FINAL
DRAINAGE PLAN AND REPORT

**A PROPOSED CHURCH AT 10695 LINDBERGH ROAD
AN UNPLATTED LOT**

County Fil No.: PPR-20-048

Revised
July 6, 2021

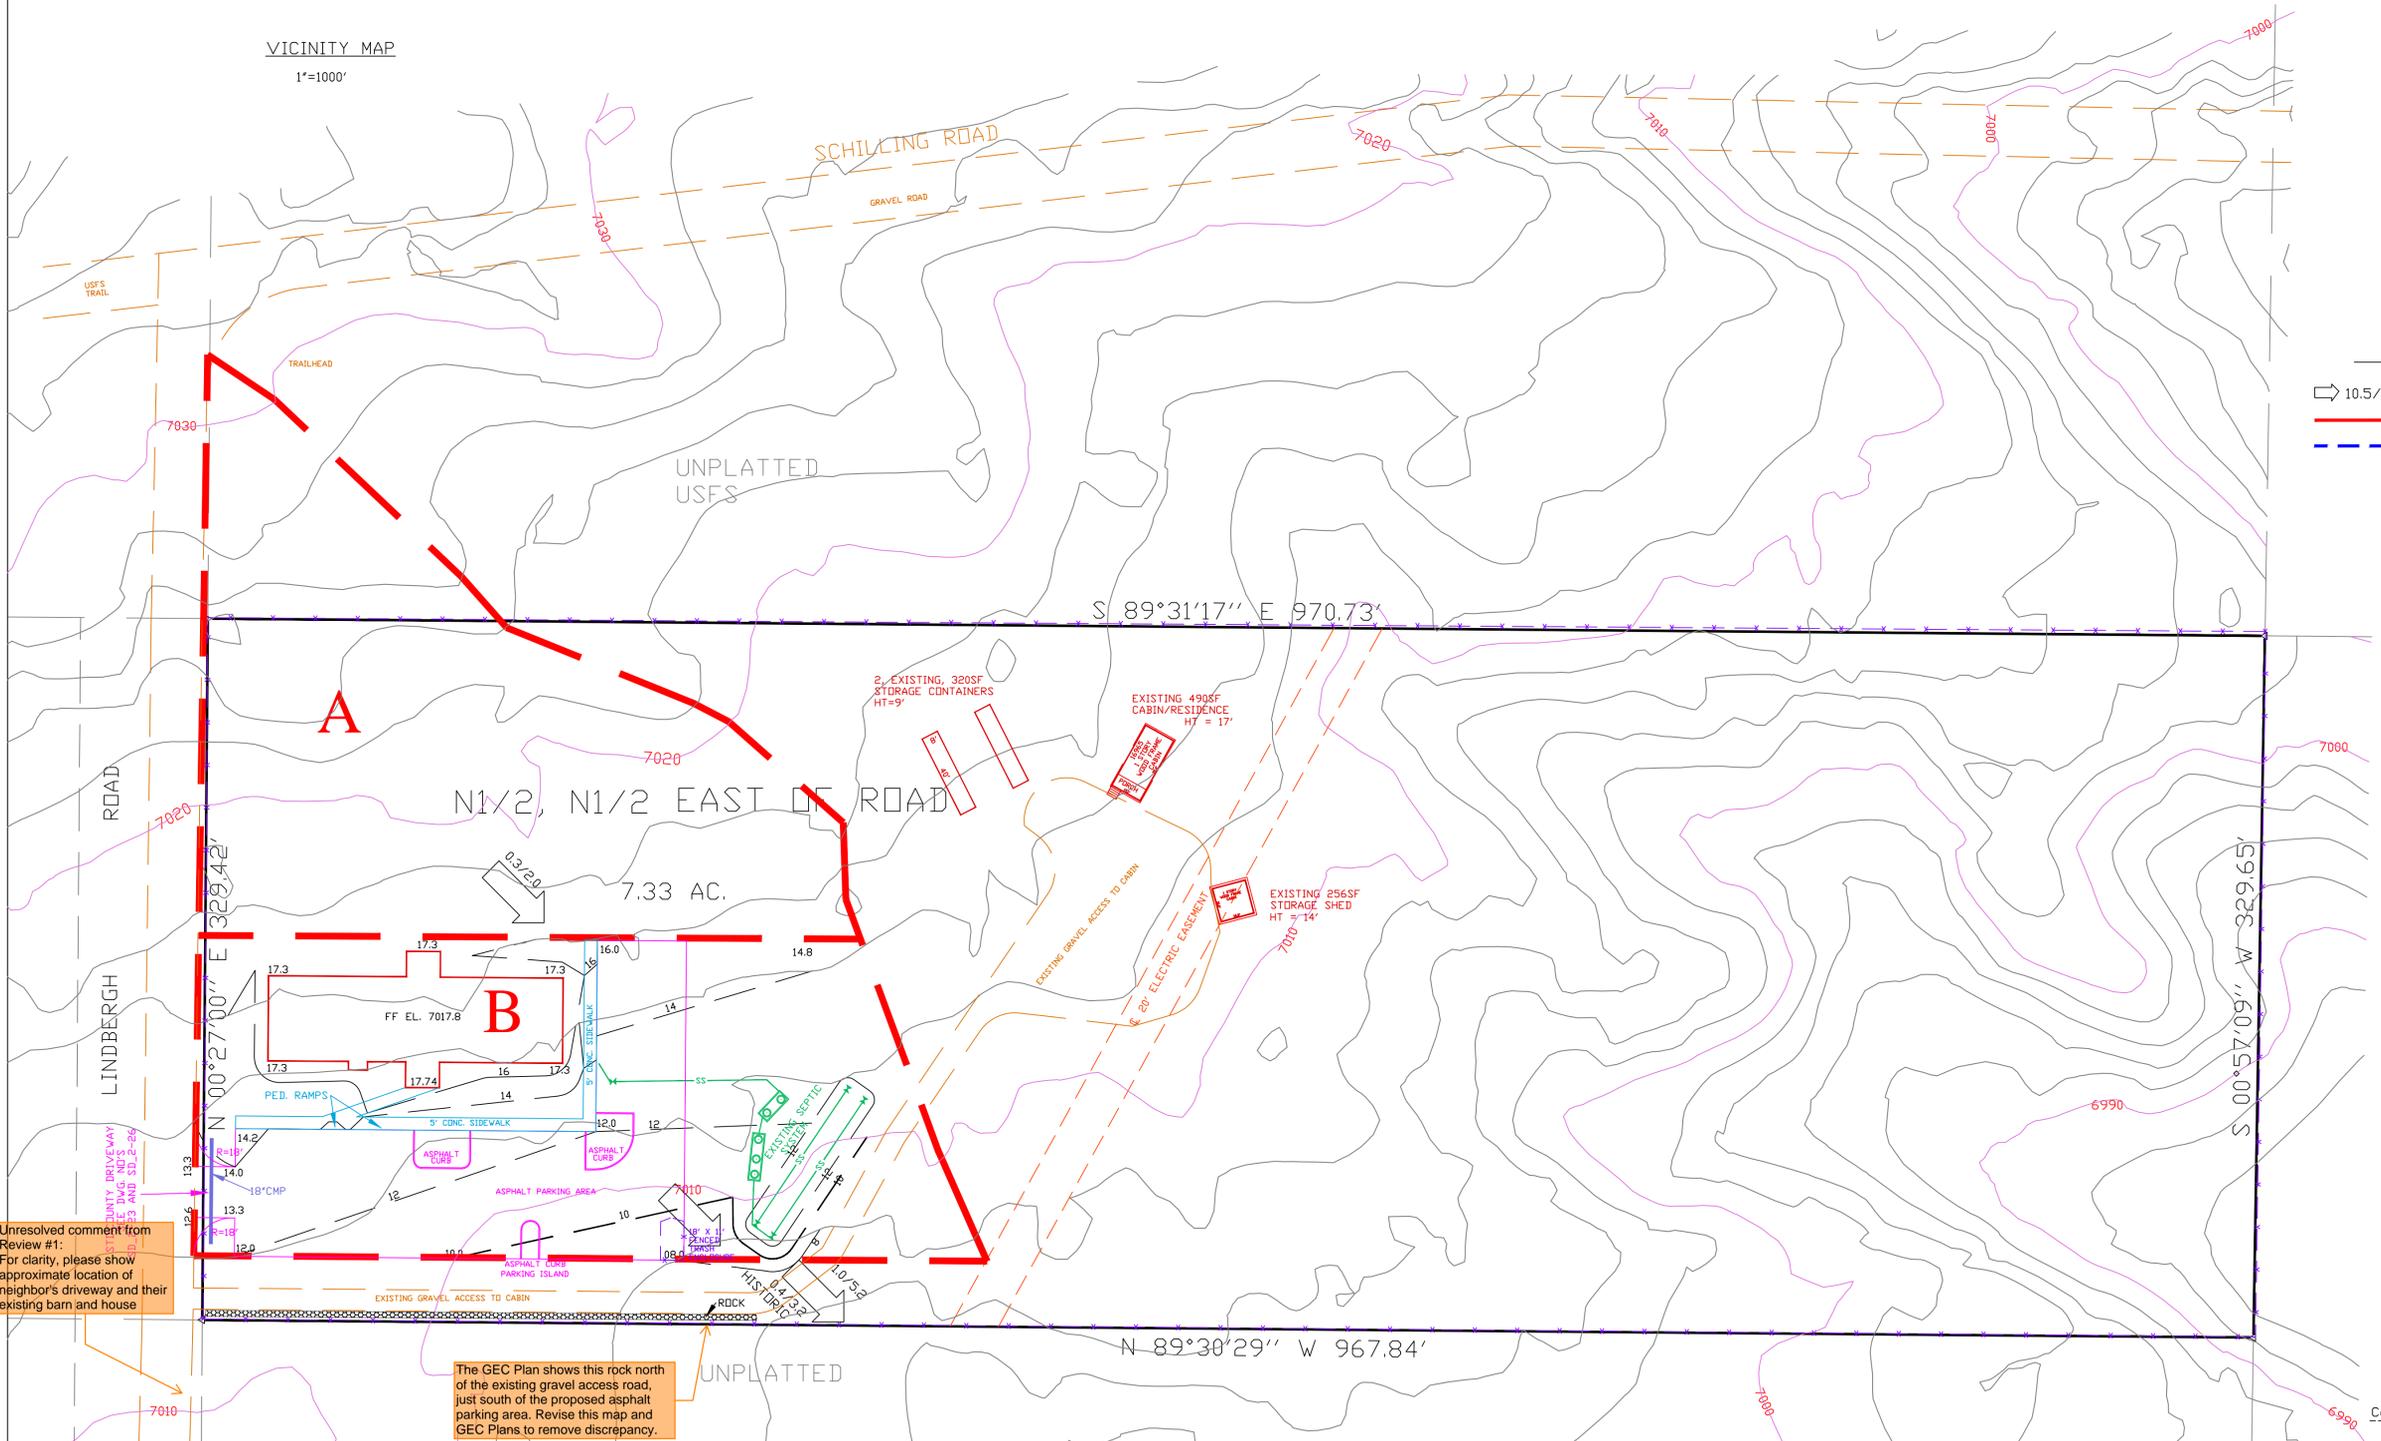
Unresolved comment from Review #1:
For clarity, please show approximate location of neighbor's driveway and their existing barn and house

The GEC Plan shows this rock north of the existing gravel access road, just south of the proposed asphalt parking area. Revise this map and GEC Plans to remove discrepancy.
